## **WEST SUFFOLK JOINT GROWTH STEERING GROUP - TUESDAY 10 MAY 2016**

# West Suffolk Joint Growth Steering Group

<b>Title of Report:</b>	<b>Mildenhall Hub: Development Brief</b>	
<b>Report No:</b>	<b>JGG/JT/16/004</b>	
<b>Report to and dates:</b>	<b>West Suffolk Joint Growth Steering Group</b>	10 May 2016
	<b>FHDC Cabinet</b>	17 May 2016
<b>Portfolio holder:</b>	James Waters Portfolio Holder for Planning and Growth <b>Tel:</b> 07771 621038 <b>Email:</b> <a href="mailto:james.waters@forest-heath.gov.uk">james.waters@forest-heath.gov.uk</a>	
<b>Lead officer:</b>	Chris Rand Principal Planning Officer (Major Projects) <b>Tel:</b> 01284 757352 <b>Email:</b> <a href="mailto:chris.rand@westsuffolk.gov.uk">chris.rand@westsuffolk.gov.uk</a>	
<b>Purpose of report:</b>	<p>Many of the buildings housing public services in Mildenhall are either coming to the end of their planned lives, or require major investment. Any growth within the town will put an extra demand on these facilities. There is the potential to bring together a number of public services on to one site in order to create a single 'hub'. This would help reduce running costs and improve public access as well as freeing up vacated

Figure 6.5

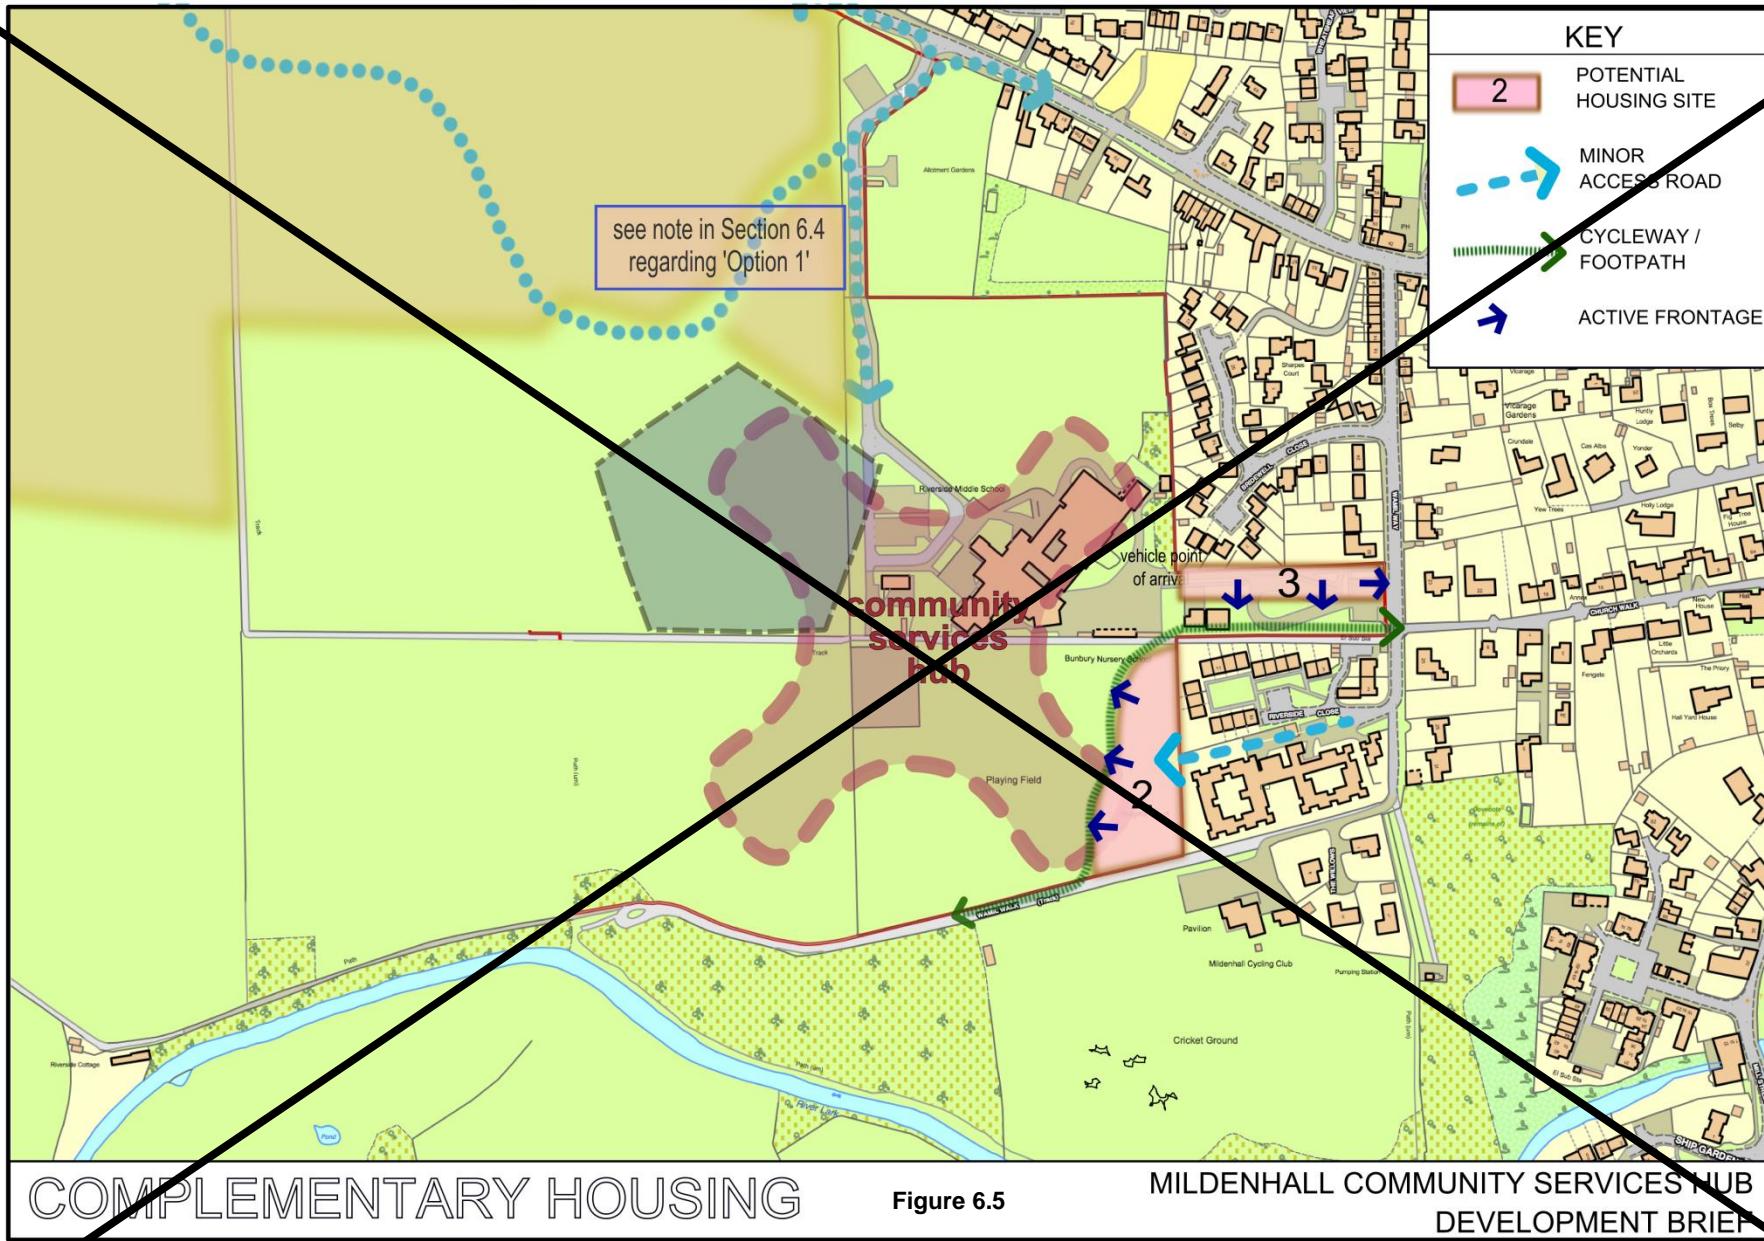
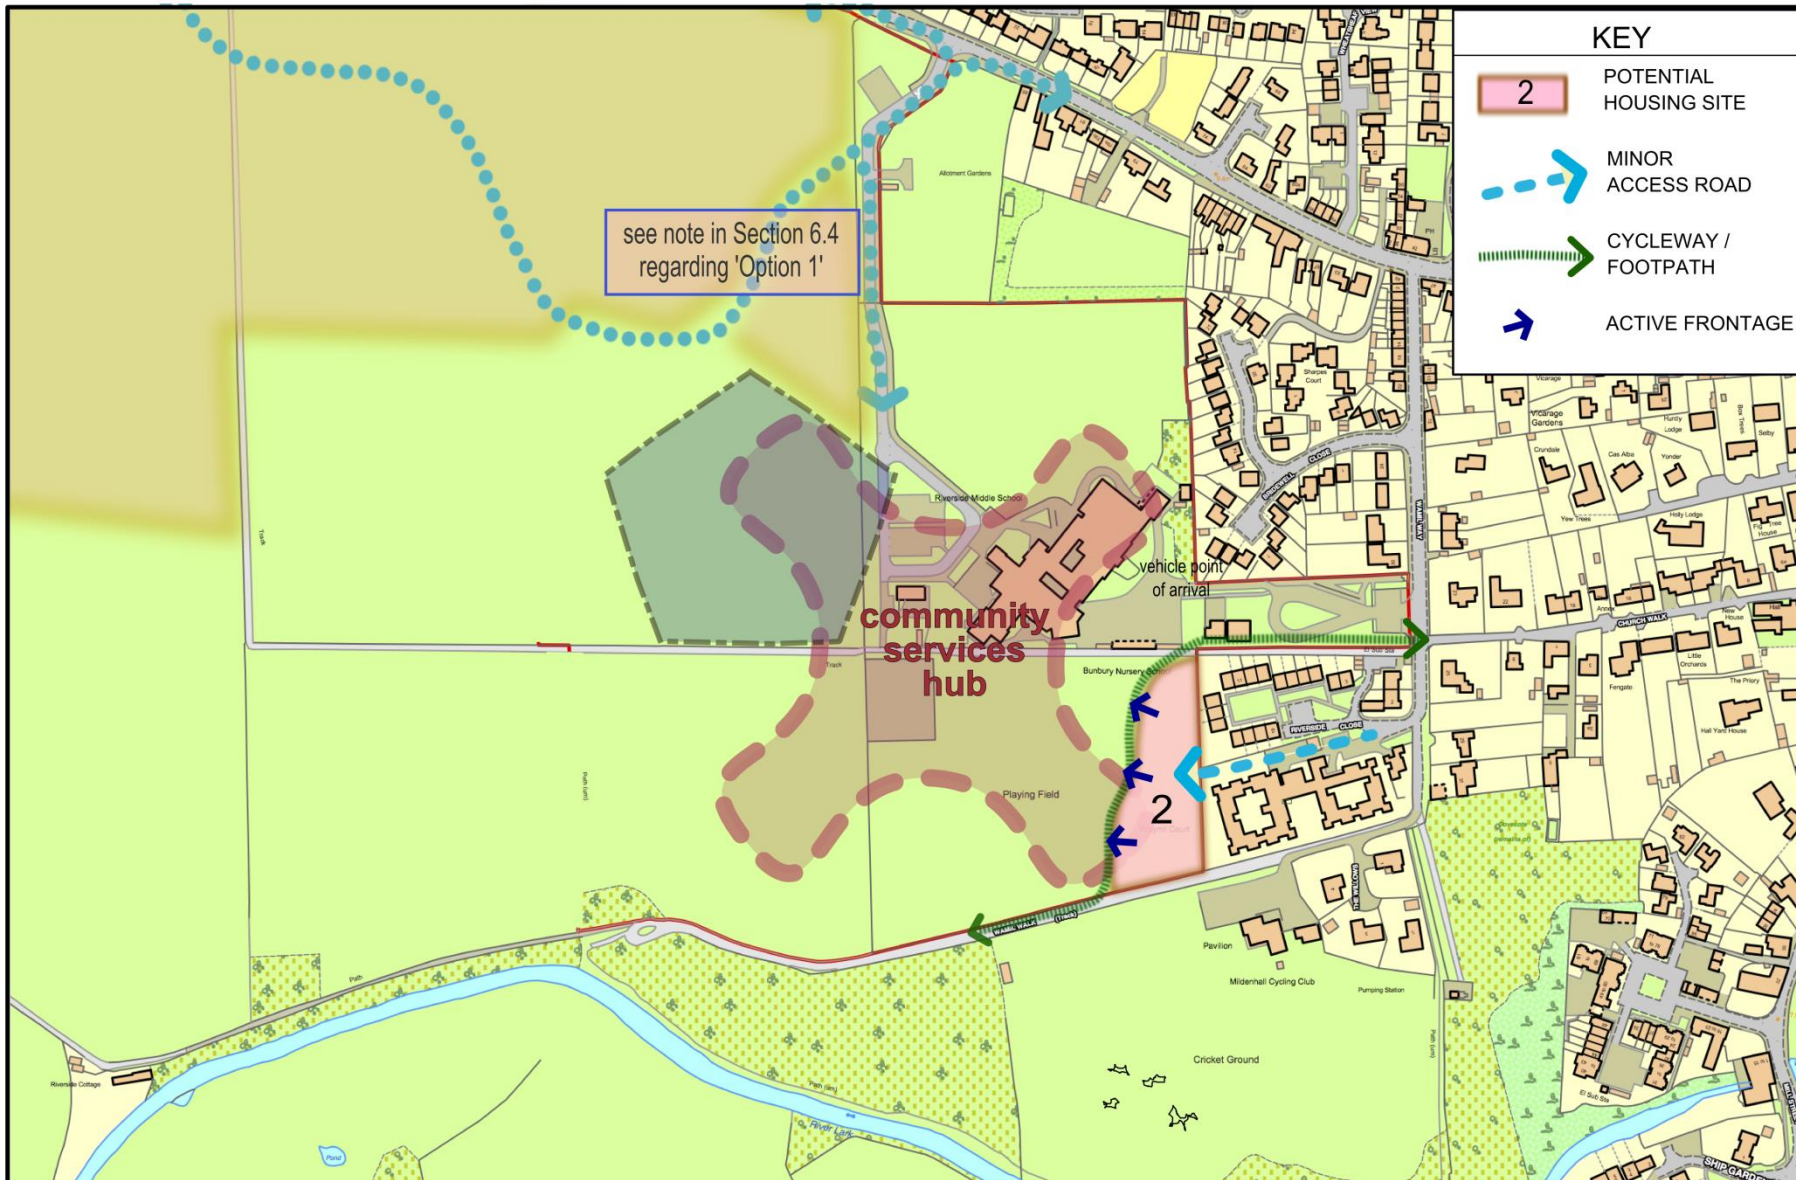
~~Option 3 (site 3 on Fig. 6.5) offers similar potential to enliven the space with active frontage however development potential here would be limited by existing trees and the shallow depth of possible plots. Existing trees provide considerable amenity to this access and any development would need to be carefully designed so as not to detract from this. A very limited number of well-spaced detached dwellings may be able to achieve this but larger dwellings would probably not be a solution as plot depths may not accommodate them.~~

~~Both sites 2 and 3~~ **Site 2** would require vehicular access to be taken from Wamil Way. Any increase in vehicular movements in Wamil Way could be offset by the ~~removal of the existing off-street car parking and~~ relocation of the pre-school to Sheldrick Way. However, this is a matter likely to be examined in more detail through other planning applications in the vicinity which will precede the Hub project.

Option 1 **(preferred)** would be to site any complementary housing to the north west of the Hub with access from Sheldrick Way. Housing in this area should sit comfortably with the proposed strategic residential development to the west, currently being considered as part of the Forest Heath Local Plan. Although referenced, this is not shown as a specific site in Fig. 6.5 as this would depend on the final layout for the main Hub facilities.

Option 2 (site 2 on Fig. 6.5) is a future but complementary extension to Wamil Court, now closed and awaiting redevelopment. The viability of this option would depend upon the determination of any preceding application for Wamil Court and the outcome of other proposed developments off Wamil Way. However, in theory at least, redevelopment of this site offers the potential to replace rear garden fencing with an active frontage to the hub development. This would help enliven the space on this side of the hub and help integrate it with other uses. If later extended into site ‘2’ to the west side of Riverside Close as shown on Fig. 6.5 the active frontage could be similarly extended to present an active frontage in lieu of the rear garden fencing of Riverside Close. The hub development in turn would need to respond with an attractive and active frontage facing the housing and a pedestrian / cycle route should be created between the two.
